# 2025/4731/P - 45 Howitt Road

# 2025/4731/P – Photos and drawings

Delegated Report (Members Briefing)		Analysis sheet  N/A / attached		Expiry Date:	17/12/2025
				Consultation Expiry Date:	23/11/2025
Officer			Application N	umber(s)	
Gary Wong			2025/4731/P		
Application	Address		Drawing Numbers		
45 Howitt Road London NW3 4LU			Refer to draft decision notice		
PO 3/4	Area Team Signate	ure C&UD	Authorised O	fficer Signature	
Proposal(s)					
rear dormer, elevational a access door	replacement ground removal of two rear re lterations including re to first floor rear, repla ear garden ground leve	ooflights and add placement windo acement roof tile	lition of two front in the second in the sec	rooflights and a re lazing and installa	ear rooflight, ation of an
Recommendation(s): Grant conditional planning permission

#### **Householder Application Granted**

Figure 4 Existing and proposed roof plan (Source: submitted documents)

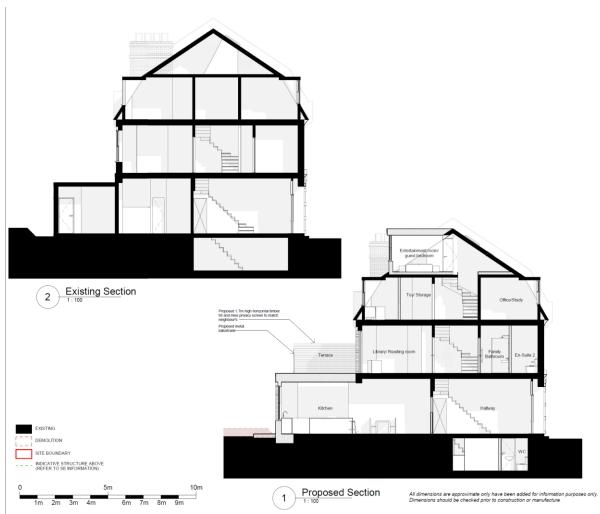
- The revised dormer is still somewhat overbearing compared with the rest of the rear elevation and unbalances it.
- The roof of the dormer reaches the roof ridge whereas most dormers are lower and therefore maintain something of the original roofscape.
- There is a considerable vertical surface below the windows which would conflict with the existing roof pitch and unbalance it.
- The width of the dormer is the same as that of the dormer below so would not be subservient.
- Two rear dormer proposals at 54 and 56 Howitt Road were refused for similar reasons.

- 2.6. The revised rear dormer has been reduced in width so that it now aligns with the existing lower rear dormer. Although it would still be larger in height than the lower dormer, its overall scale remains subordinate to the main rear roof. While the dormer would extend up to the main roof ridge, it would retain sufficient separation from both flank walls and the eaves to avoid appearing overly dominant. Due to its location at the rear, the dormer would not be visible from the front along Howitt Road. The proposed glazing-to-solid ratio is acceptable, and the use of slate cladding would match the existing roof materials. Overall, the revised dormer is considered to maintain an appropriate degree of subservience to the host roof.

- The width of the proposed dormer has been reduced and aligned with the lower rear dormer. Whilst it would sit flush with the main roof ridge, with the reduction in width it is now considered subordinate to the rear roof.
- The glazing/solid ratio of the proposed dormer is considered acceptable and in line with CPG Home Improvements.
- The refusal examples given were from the opposite side of Howitt Road which has a different context of roofscape. Along the even number side of Howitt Road, the overall roofscape of these terraces remain largely unaltered. The rear roofscape of this odd number side of Howitt Road has already been altered significantly throughout time. Therefore the site context material to the planning assessment would be different.
- Please refer to Section 2 for assessment on design and heritage impact.
- Please refer to Section 3 for assessment on amenity impact.
